September 11, 2024

Project No: 100200.32

**ADDENDUM NO. 2
TO THE CONTRACT DOCUMENTS AND DRAWINGS**

**For the construction of the
Aloe Bay Water Quality Enhancement Wastewater Treatment Facility**

$3/16" = 1'-0"$

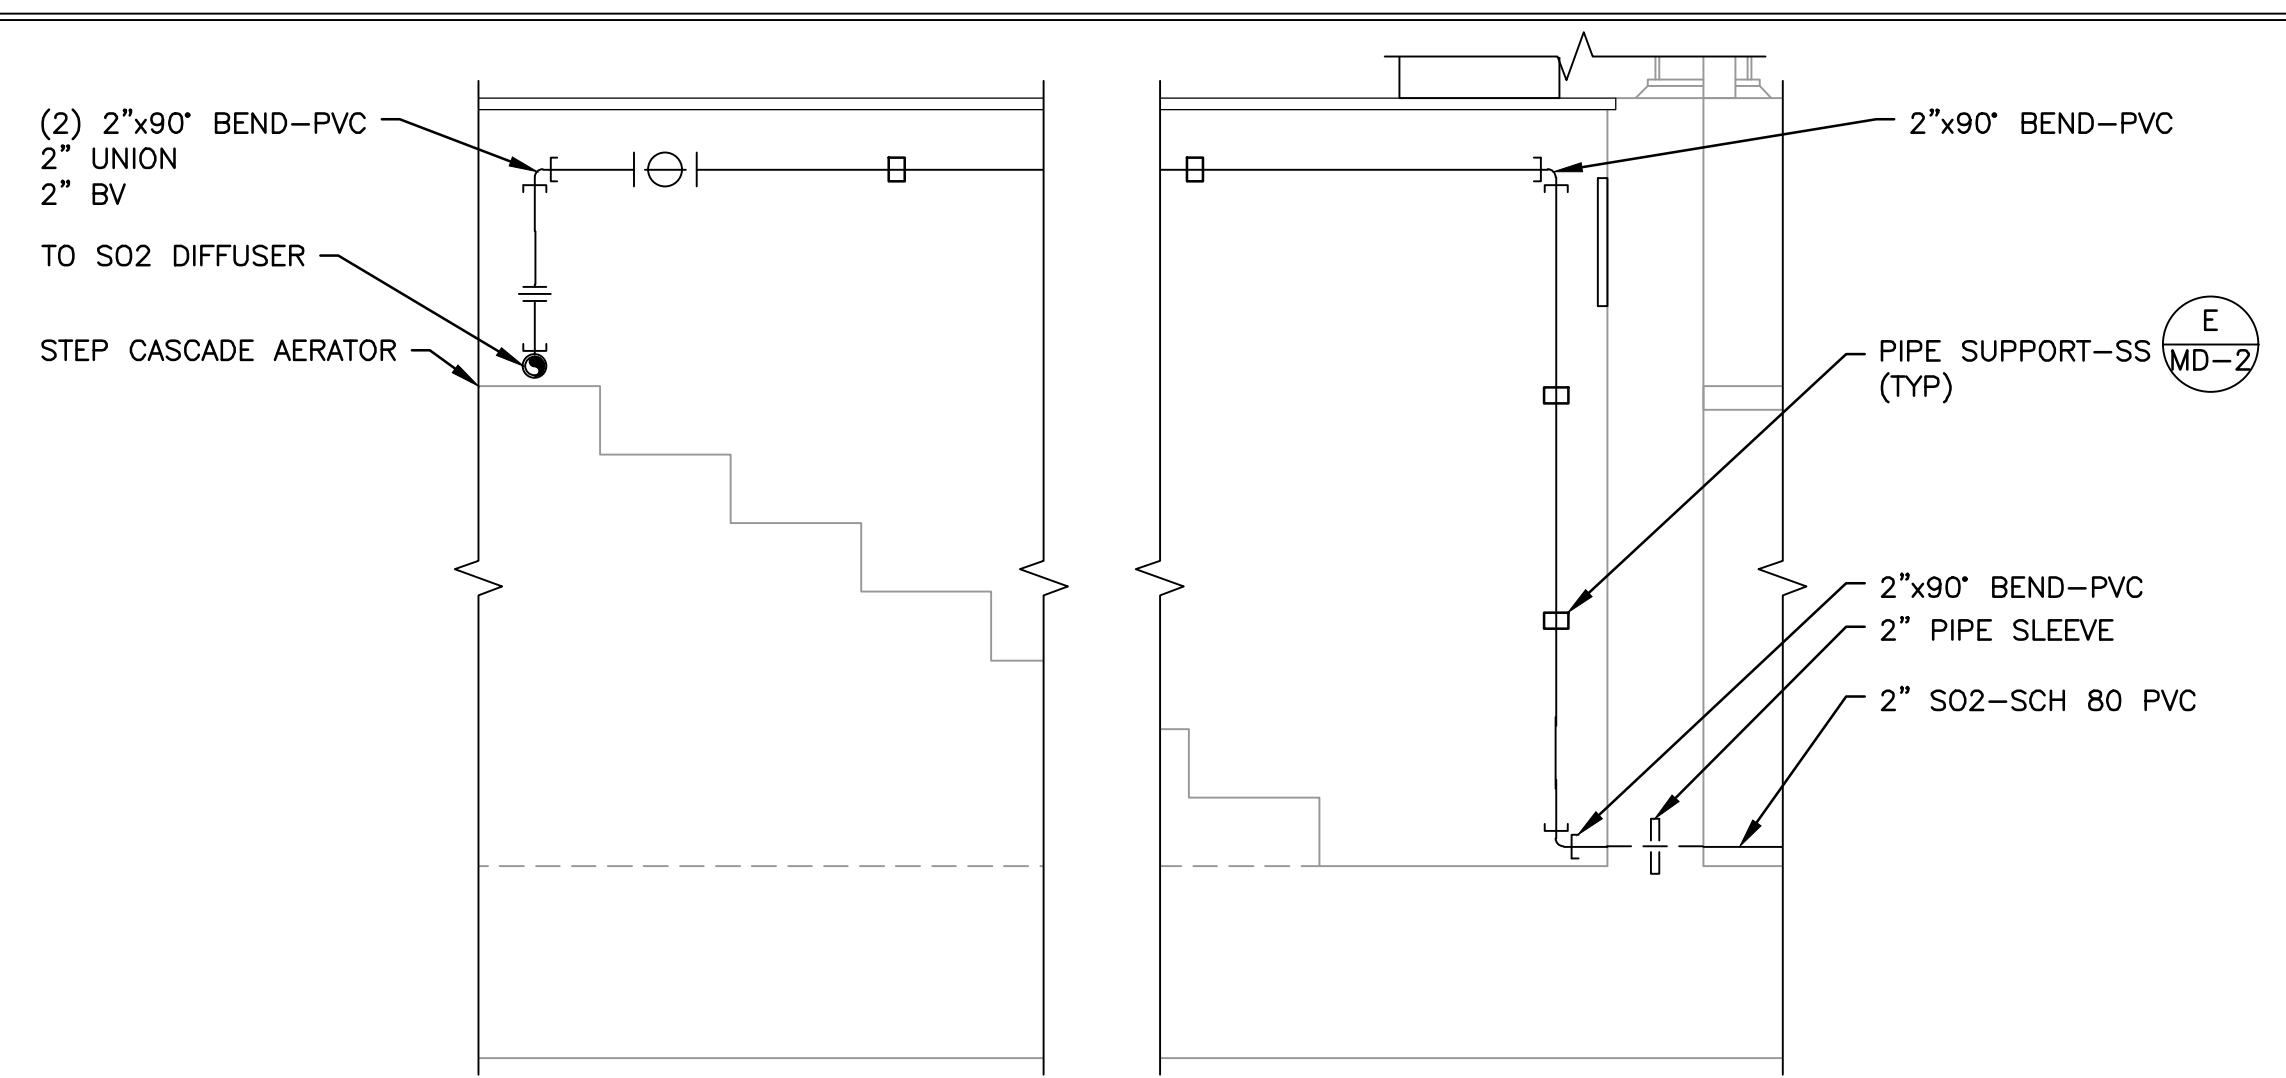
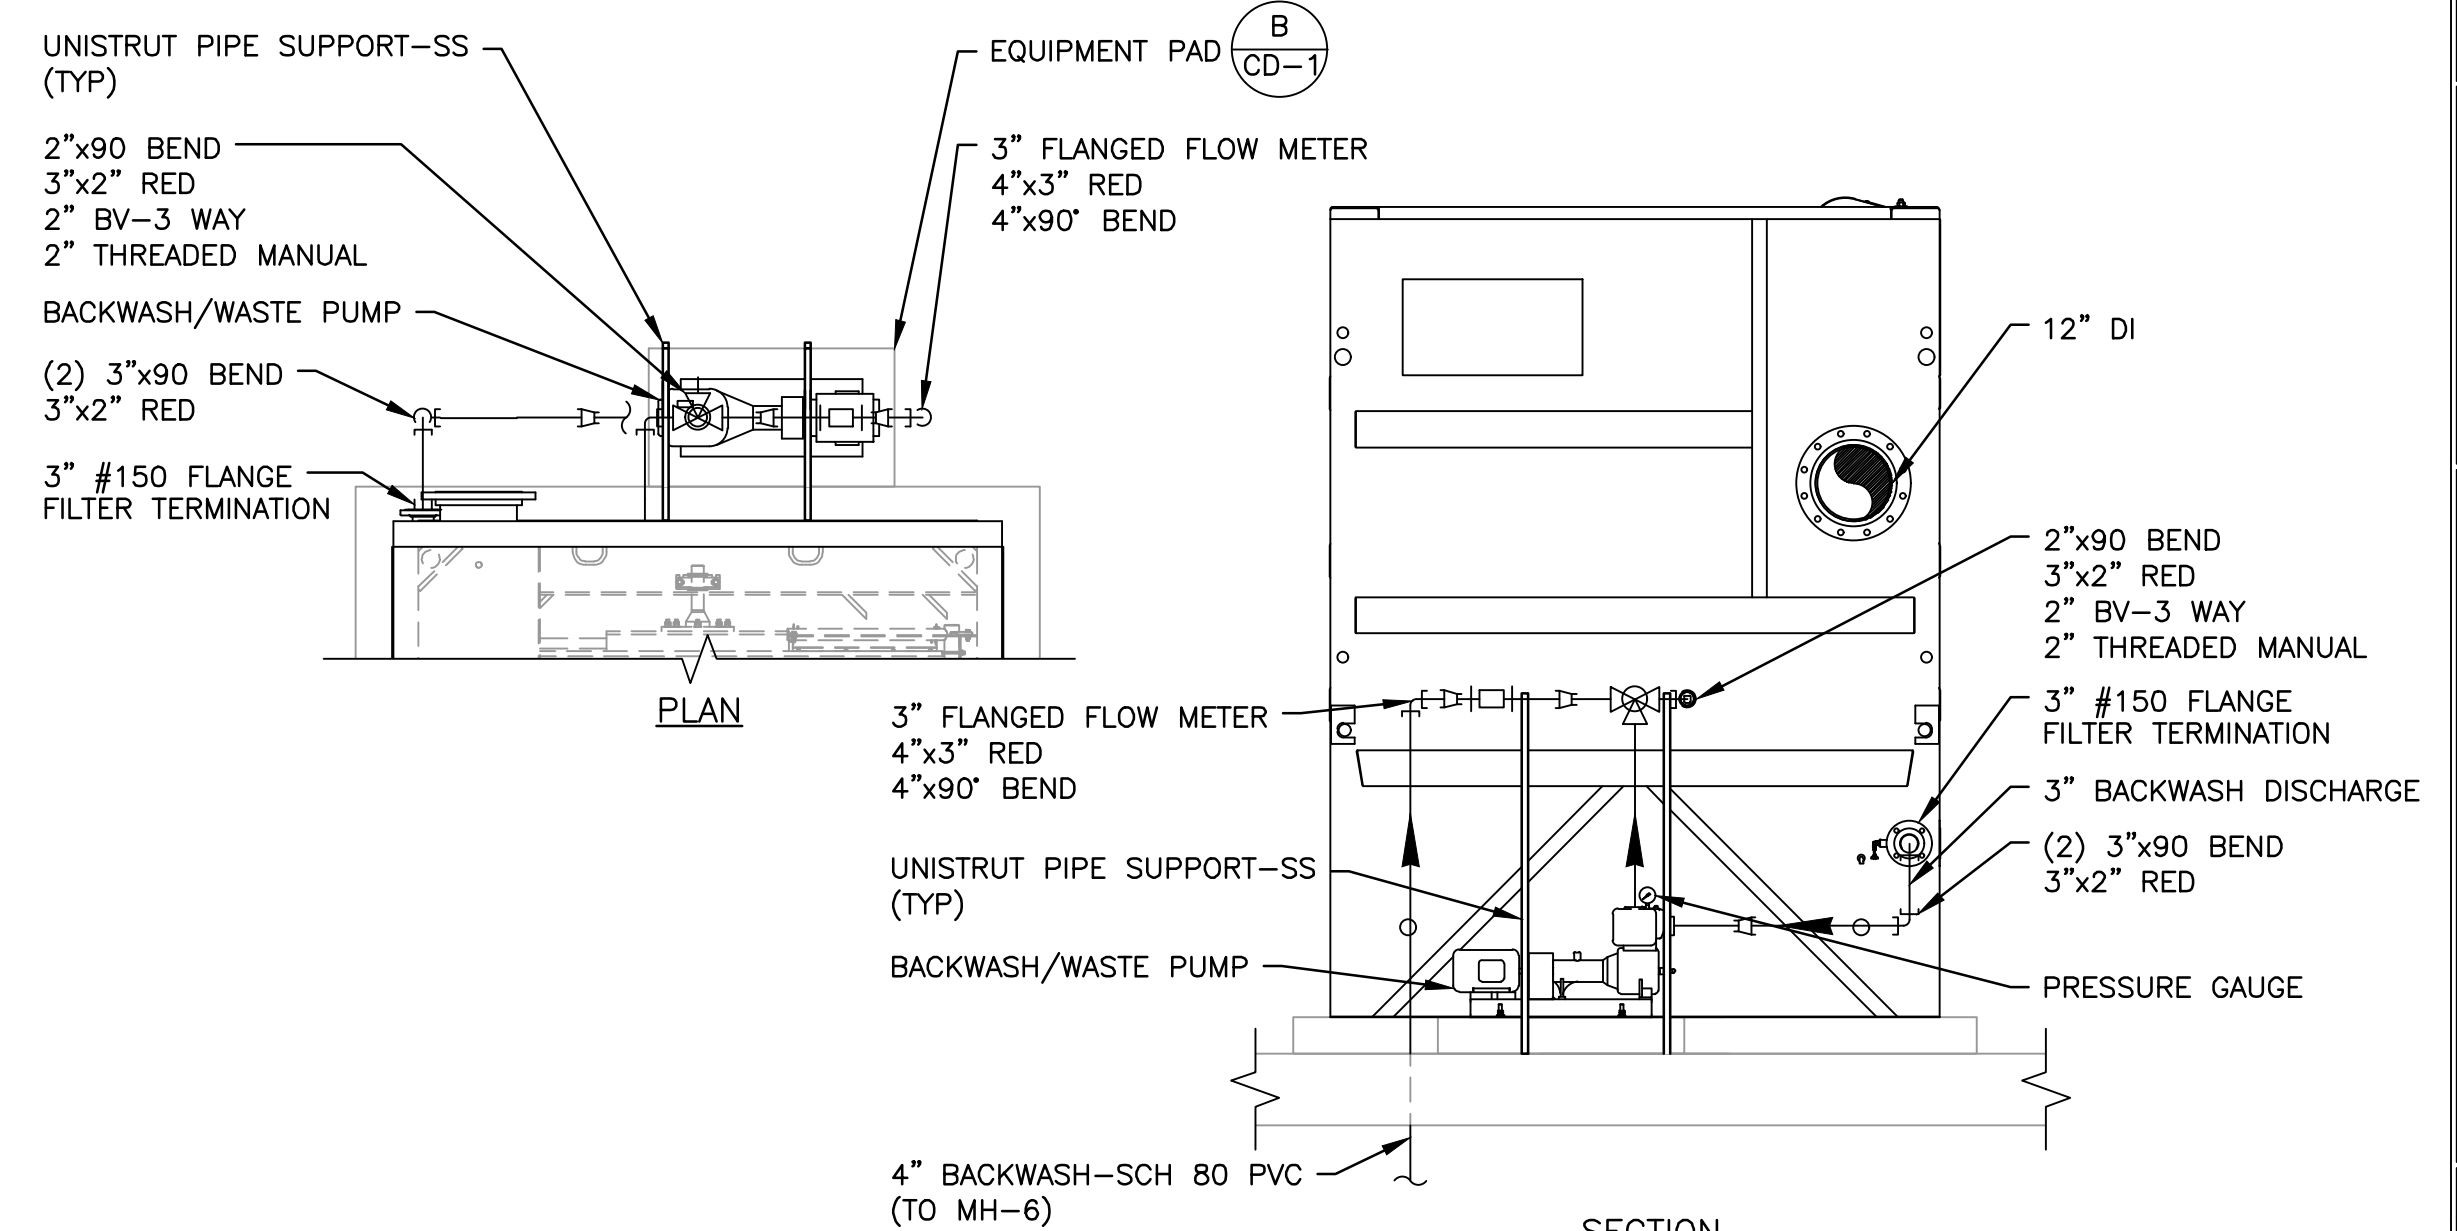
2	9/6	ADDENDUM 2	BL	JS
DESIGNED BY:	DATE	REVISION	APPROVED BY:	APPROVED BY:
BL		DRAWN BY:	JS	
		LR	SC

PANEL LV SCHEDULE
SCALE: NONE

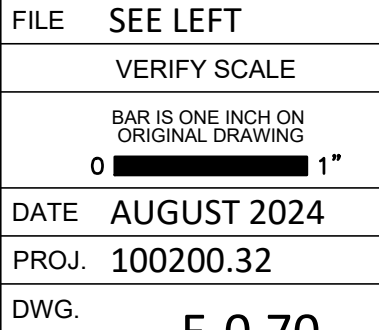
4. The two pole 20A circuit breaker allotted to provide power for the “Headworks Screen Air Compressor” from Panel LV (drawing E-0.70) shall be revised to be a spare and the “Headworks Screen Air Compressor” shall be relocated to one of the spare single pole 20A breakers.
5. The “Headworks Compressor” in the “MCC Load Schedule” on drawing E-0.73 shall be omitted.
6. The P9 power feeder (consisting of 3#12 and 1#12 G in a 1” conduit) shown on drawing E-3.0 “Mechanical Screen Air Compressor” shall be replaced with a P15 power feeder (consisting of 3#12 in a ¾” conduit). The associated disconnect switch shall be replaced with a weatherproof while-in-use GFI receptacle to provide power for the compressor.
